# MEMORANDUM

111 CYPRESS STREET, BROOKLINE, MA

DATE: August 11, 2017  
TO: James Fitzgerald, P.E., LEED AP  
COMPANY: Environmental Partners Group, Inc.  
ADDRESS: 1900 Crown Colony Drive, Suite 402  
CITY/STATE: Quincy, MA 02169  
CC:  
FROM: Arthur G. Stadig, P.E.  
PROJECT NAME: 111 Cypress Street, Brookline, MA  
PROJECT NUMBER: 16-2822.00  
SUBJECT: Peer Review of Parking

## Basement Floor Plan

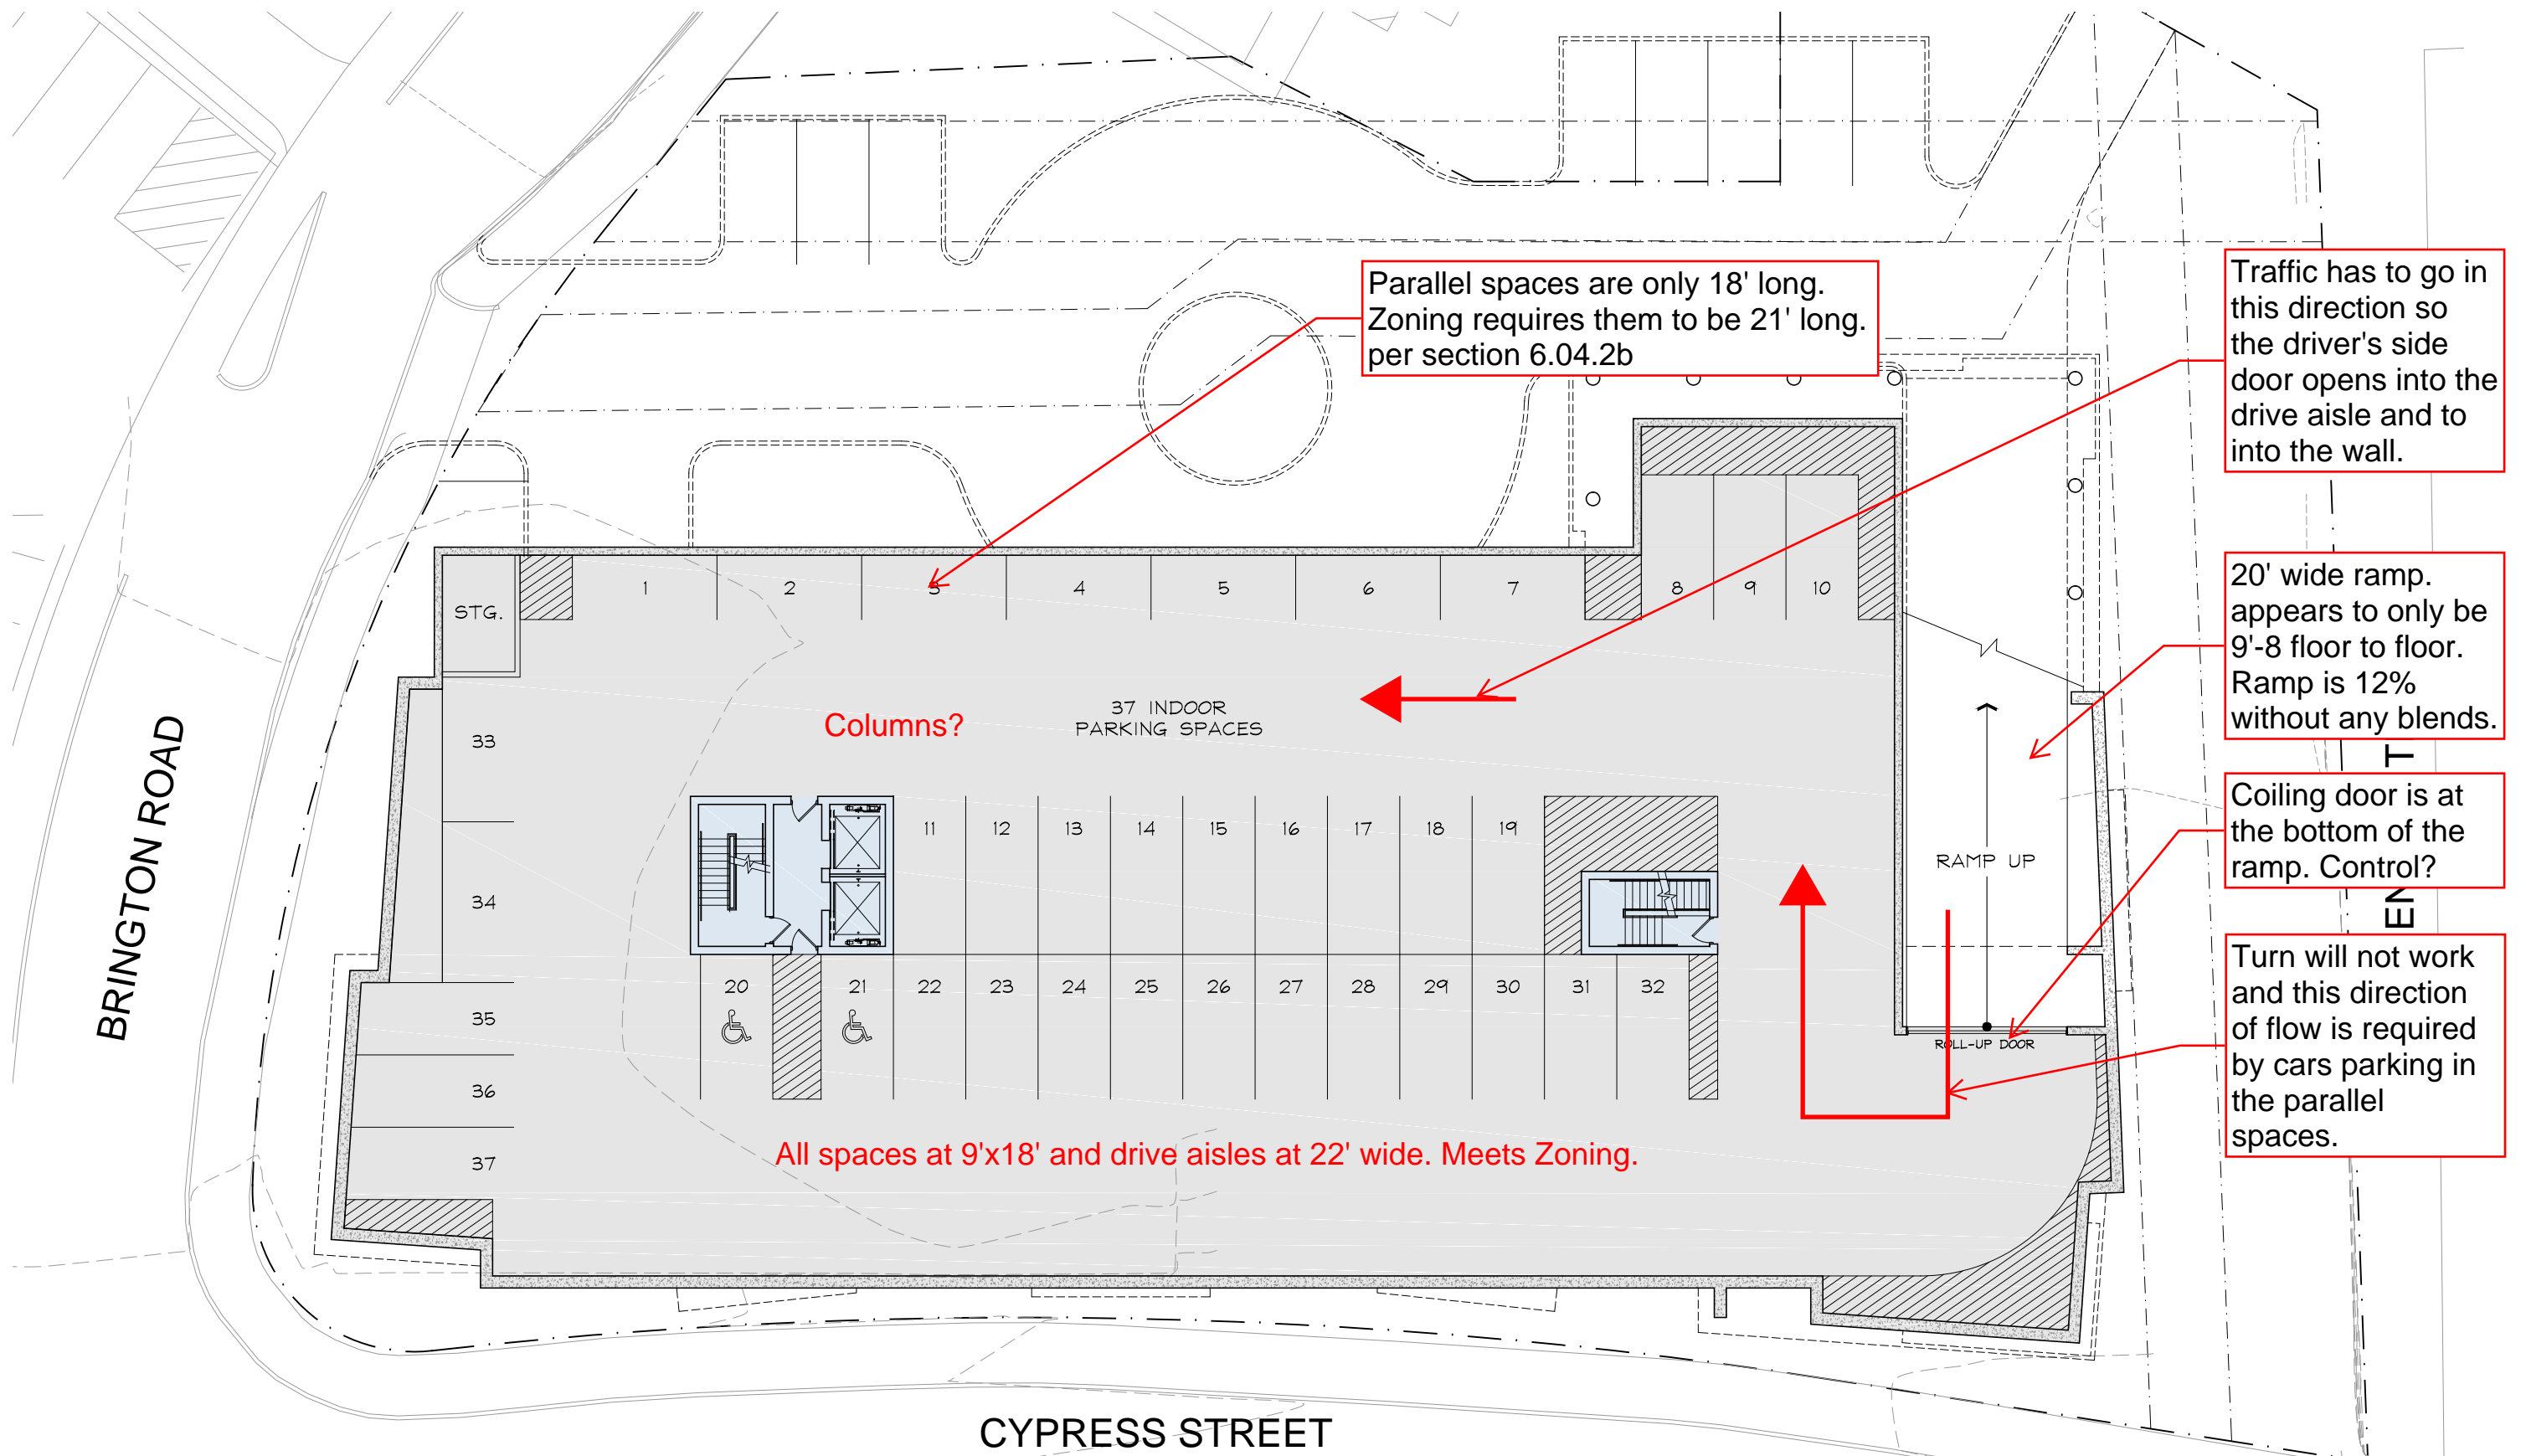
5. Basement parking plan comments:
  - a. The ramp to the parking is 12%. Without proper blend ramps, cars may frequently bottom-out at the top and bottom of the ramp with this steep of slope.

- b. Cars cannot make the U-turn around the end of the ramp into the adjacent drive aisle parallel to it. This has an impact on parking in the parallel spaces on the southern and western walls of the garage. It is highly preferred that the driver's side door opens to the drive aisle and not towards the wall, requiring a counter-clockwise traffic flow on the plan.

- c. Parallel spaces are only 18' long and do not meet the zoning ordinance. They are required to be 21' long.
  - d. Parallel space #1 cannot be parked properly by backing into the parallel space with counter-clockwise circulation.

parallel spaces are required to be 21' long per Zoning section 6.04.2b

First Floor Plan

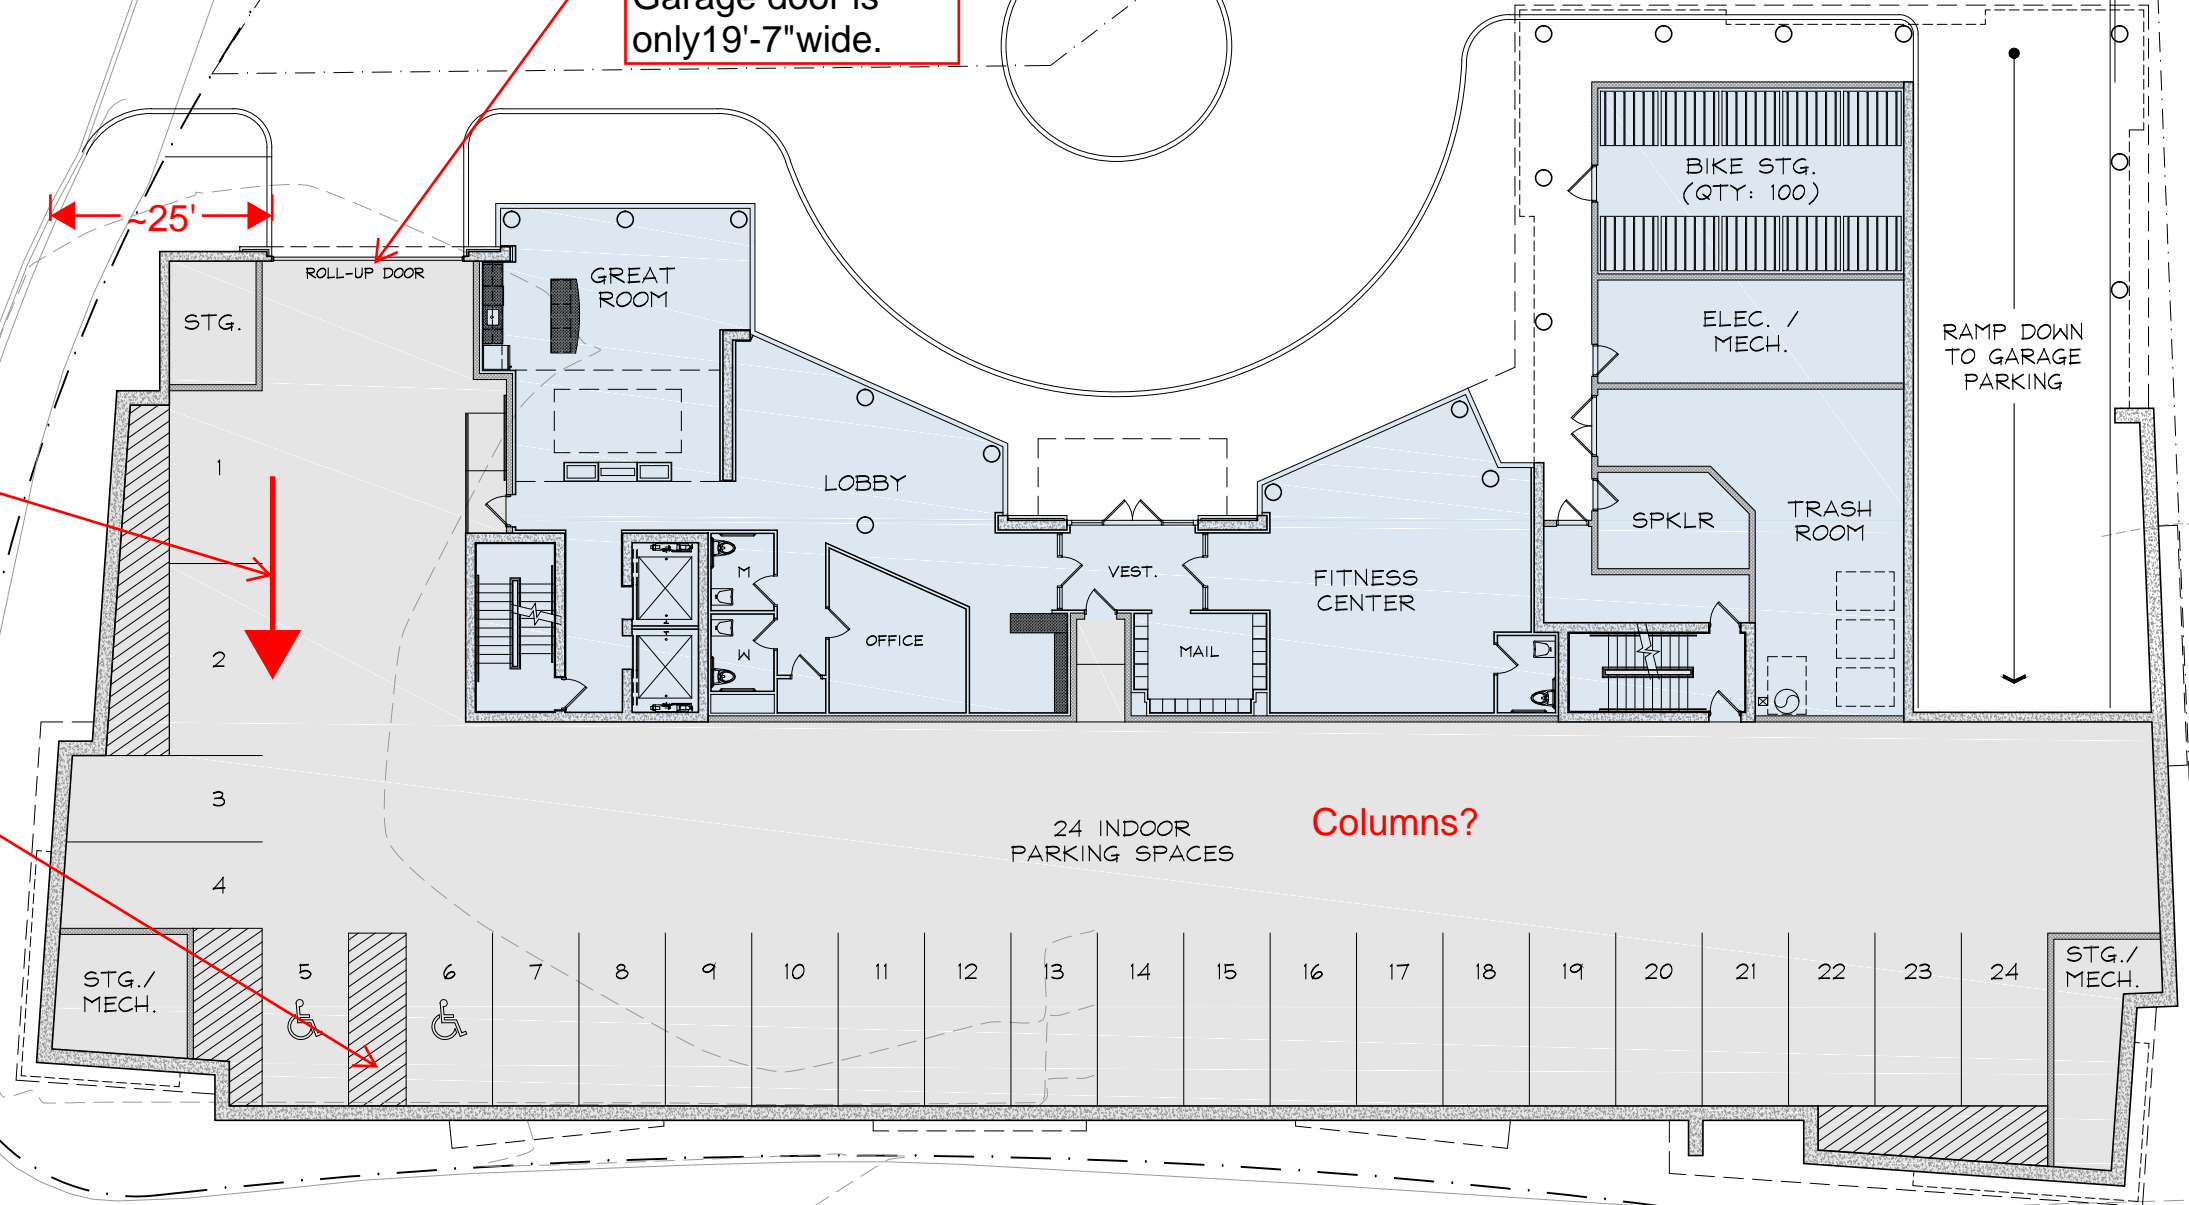
6. First floor parking plan comments:
  - a. The parallel spaces along the southern wall can be parked in with the expected flow of traffic in to the garage. When exiting they must turn around and there is no place for that to occur. A U-turn is very difficult with multi-point turns.

The arrow illustrates the direction the car has to park in order to keep the drivers side door opening into the aisle and not the wall. Once the cars are parked, where will they turn around to exit?

Curb cut is 20'. Garage door is only 19'-7" wide.

The access aisle needs be to 8'-0" wide per MA Accessibility Regulation and ADAAG. 8'-2" clear headroom is required to, from and at the parking space. Can this be accommodated?
